**General Bid Bulletin No. 34**  
**23 June 2021**

**IFB No. 20-031-6**

**SOUTH COMMUTER RAILWAY PROJECT**  
**FOR PACKAGES CP S-04, CP S-05, CP S-06, AND CP S-07;**  
**CONSTRUCTION OF CIVIL STRUCTURES: VIADUCTS, BRIDGES,**  
**NINE STATIONS (9) AND DEPOT**

## CP S04-07 Responses to Clarification Requests (Batch 20)

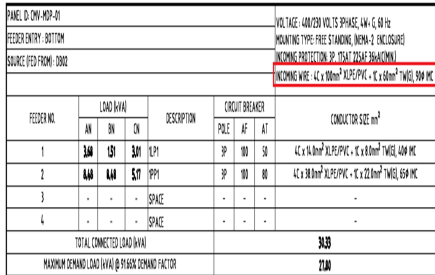
Packages	Vol	Sec	Page No.	Clause No./Title	Reference Text (if necessary)	Clarification Request	<i>Final Response</i>
S-04		Vol. 2 Sec 6 IC General Specification TS 500 – Architectural Works	TS 500 - 246	523.1 The Work	<p>The works (supply and installation onsite) specifically exclude scaffoldings, stock yard, heavy machines for unloading materials onsite, structural steel and secondary steel (material supply-fabrication-installation), gutter, temporary storage, mockup, drawing submissions, permitting (approvals from Government), inspection, taxes, and the like.</p> <p>While secondary steel (material supply-fabrication-installation) do not form part of the work scope of the TMRS supplier, they are however required to provide the details and quantities to the secondary steel fabricator.</p>	<p>Please clarify that excluded works (scaffoldings, stock yard, heavy machines for unloading materials onsite and etc.) are refelcted which item.</p>	<p><i>Bidder is referred to the Revised TS523.1 under Addendum 6</i></p> <p><i>Below is the REVISED scope of work under TS 523.1 (The Work):</i></p> <p><i>The works in this section shall consist of the manufacture/supply, delivery and installation onsite of tensile membrane roof structure, including all anchorage provisions, in accordance with this Specification and in conformity with the Drawings or as established by the Engineer.</i></p> <p><i>The works (supply and installation onsite) specifically include membrane fabrication, membrane-fixing materials, flashing, expansion, joint cover, catch basin, drainage and transportation-handling-storage (DDU to project site).</i></p> <p><i>The works (supply and installation onsite) specifically INCLUDE ALSO, stock yard, heavy machines for unloading materials onsite, structural steel and secondary steel (material supply-fabrication- installation), gutter, temporary storage, mockup, drawing submissions, permitting (approvals from Government), inspection, taxes, and the like, and scaffolding and heavy machinery/ equipment.</i></p>

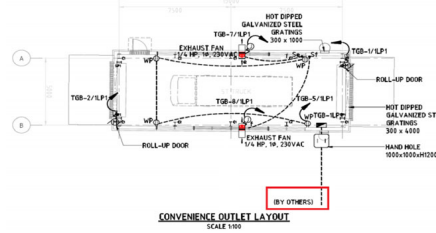
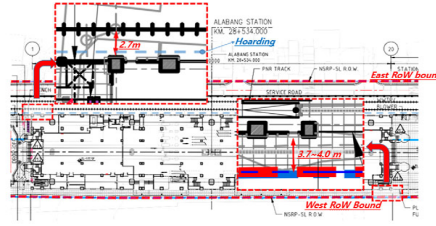
S-05		Vol. 3 Section 8 14.1 / The Contract Price  Responses to Clarification Requests in Batch 8	3.1 CP S-05 Vol.3 Sec.7-8 COC 20210304 16 page	14.1 The Contract Price  Responses to Clarification Requests in Batch 8	<p>[14.1 The Contract Price] The following sentence under Clause 14.1 shall not apply: Notwithstanding the provisions of subparagraph (b), Contractor's Equipment, including essential spare parts therefor, imported by the Contractor for the sole purpose of executing the Contract shall be exempt from the payment of import duties and taxes upon importation.</p> <p>[Responses to Clarification Requests in Batch 8] The Contractor does not pay for import taxes. Contractor needs to submit in advance a list of items to be imported monthly to DOTr, then DOTr will issue a Certificate of Undertaking to the Bureau of Customs.</p>	<p>Please clarify that definition of "list of items". Is this list including material, equipment and spare parts items which are to purpose of executing the Contract?</p>	<p><i>The payment of import taxes is not exempt, but assumed by Government of the Philippines. The assumption of import taxes extends to permanent structure</i></p>

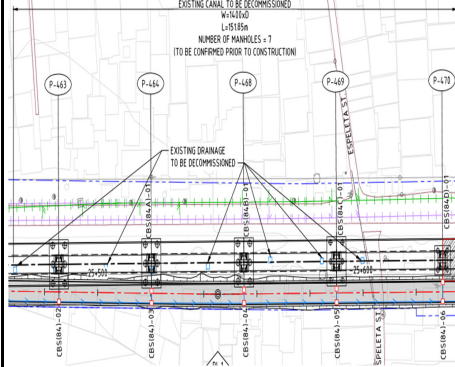
S-05				Protective Concrete	GBB 21, 21 April 2021	With reference to the response "Contractor shall place protective concrete before setting the track slab." we have the following queries:  - Please provide for the detailed dimension and the setting out details for the box out, which is allowed for the track slab construction; - What is the allowable tolerance of the box out for the protective concrete construction?	<i>The bidder is required to refer to the drawing VIA00-ST-0061 &amp; 0062 for dimension. The allowable tolerance shall be ±5mm. Water pass through the track slab will be designed and provided by others. E&amp;M contractor shall provide drain out through track slab with 150mm dia. half pipe 5m interval.</i>
